## Response to KCC Highways Objection dated 12<sup>th</sup> May 2025:

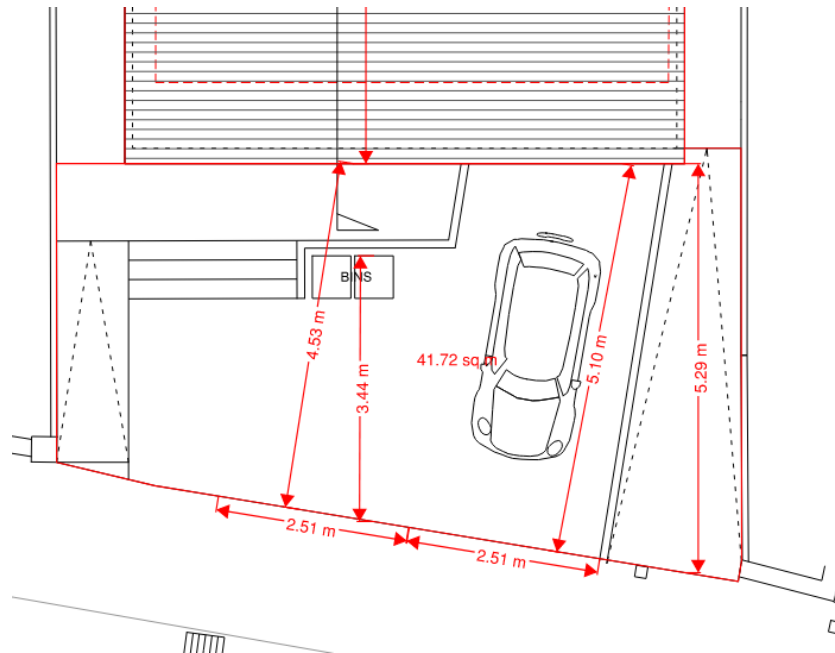
KCC Highways have requested an additional parking space to be provided. The provision of an additional parking space has been considered however due to site constraints this is not possible. To meet standards, parking spaces should measure 2.5 x 5m. The below extract from the site plan demonstrates that it is not possible to provide an additional space which complies with the required standards. Should the entrance arrangement for the dwelling be reconfigured, the space would still not be of a sufficient depth.

As such, due regard has been given to providing an additional parking space, however the constraints of the site mean that this is not a workable solution.
